Wisconsin Department of Transportation

Proposal #10:

1130-66-71, WISC 2027011
Appleton - De Pere
I-41 Mainline, Holland-CTH N
IH 41
Outagamie County

This is Addendum No. 01, which provides for the following:

PROJECT NO: 1130-66-72	HWY: IH 41	COUNTY: OUTAGAMIE	PERMANENT SIGNING	SHEET 343	E

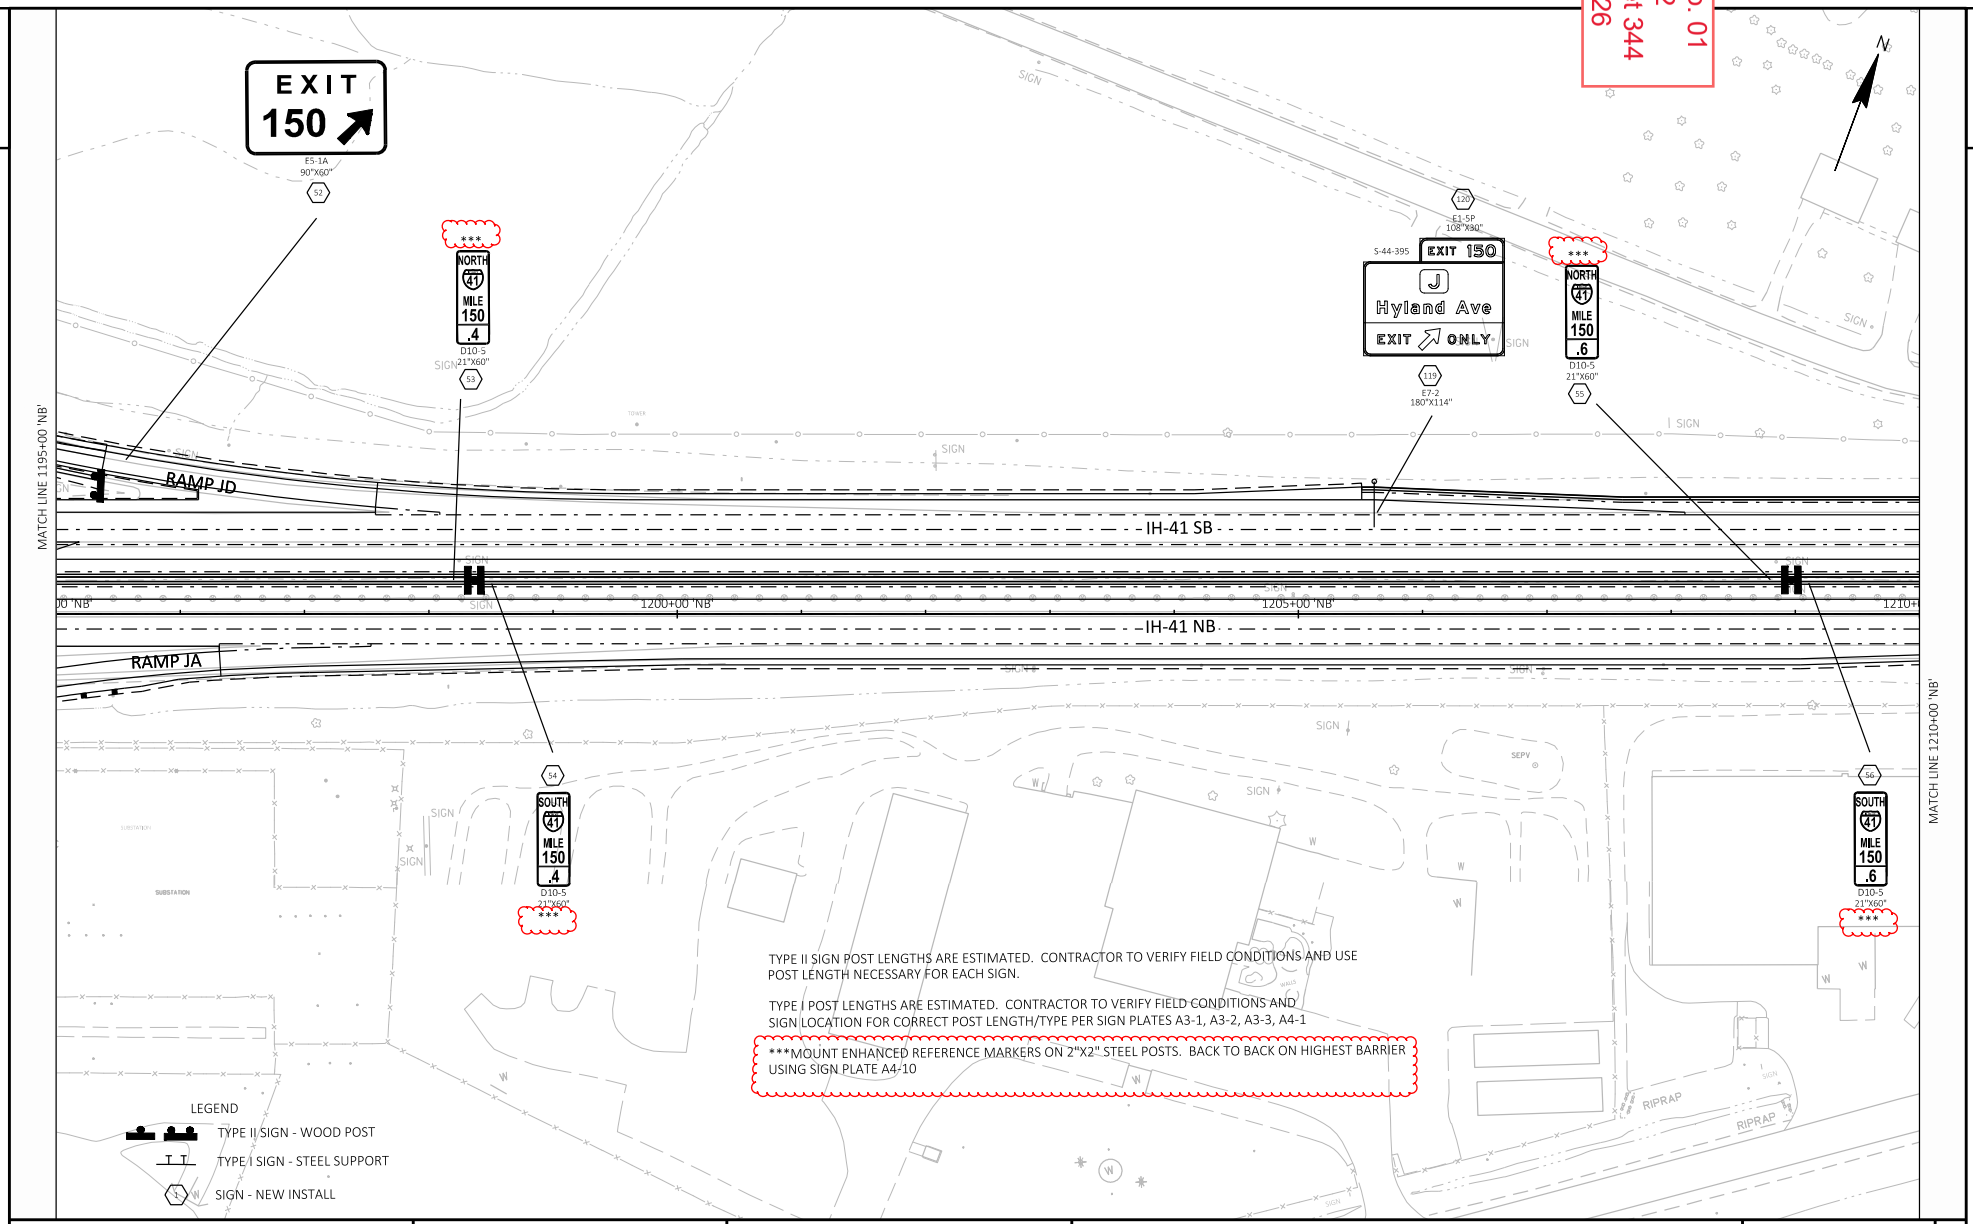
Revised Plan Sheets (1130-66-72)	
Plan Sheet	Plan Sheet Title (brief description of changes to sheet)
336-347	Permanent Signing (added note to mount Enhanced Reference Markers on 2”x2” steel posts)
647	Miscellaneous Quantities (Updated Earthwork Summary Table to add DGD Surcharge to Stage 1A)
649	Miscellaneous Quantities (Added EBS Backfill row)
651	Miscellaneous Quantities (Revised Tack Coat quantity in the Asphaltic Items Table)
672-673	Miscellaneous Quantities (Revised Type II signing table to include Posts Tubular Steel 2x2-Inch x 8-FT)
679	Miscellaneous Quantities (Added table for CTH J and CTH OO intersection signing and marking)
1080	B-44-0041 revisions
1081-1082	B-44-0043 revisions
1284	Earthwork (Added DGD end area table)

PROJECT NO: 1130-66-72	HWY: IH 41	COUNTY: OUTAGAMIE	PERMANENT SIGNING	SHEET 344	E

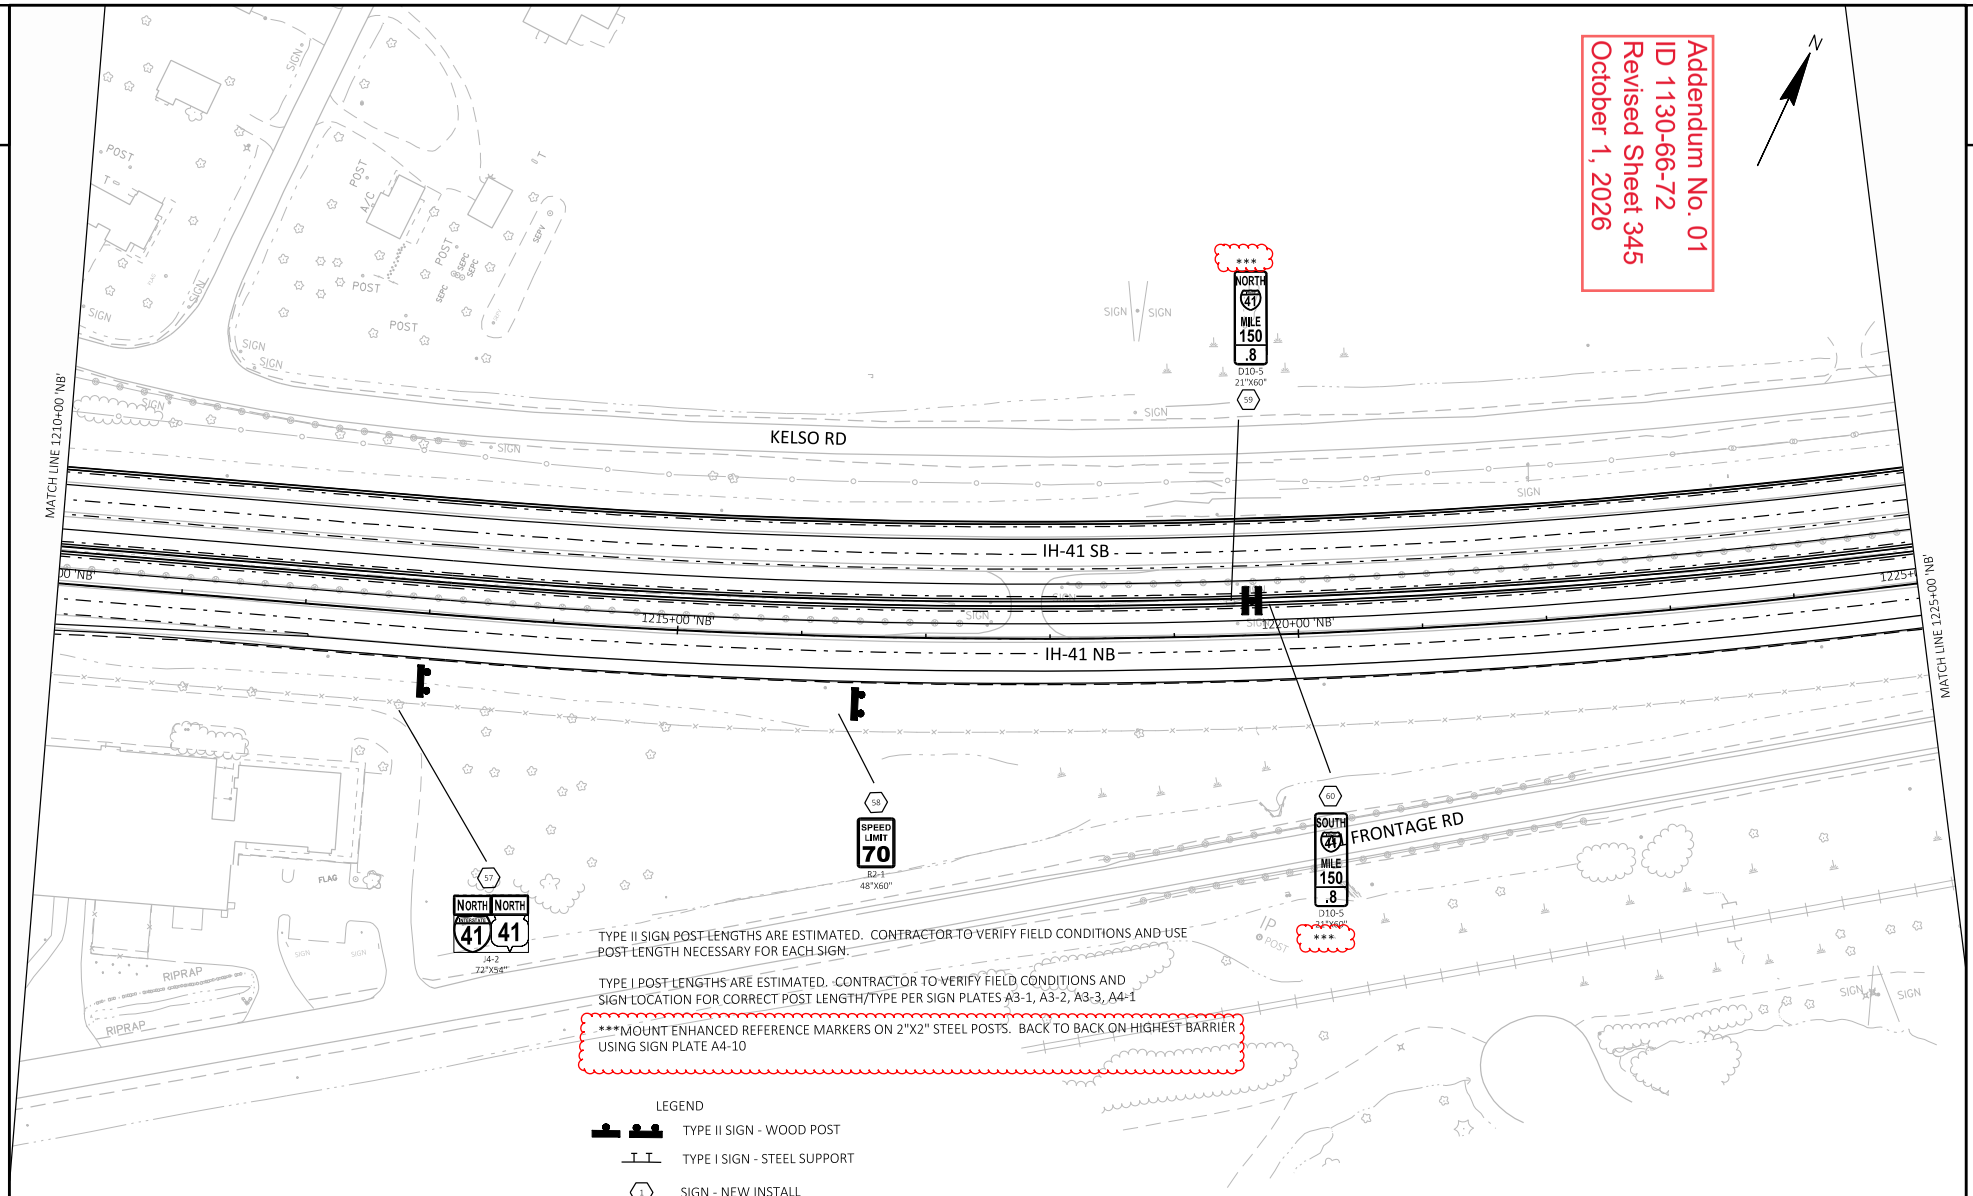
***MOUNT ENHANCED REFERENCE MARKERS ON 2"X2" STEEL POSTS. BACK TO BACK ON HIGHEST BARRIER USING SIGN PLATE A4-10
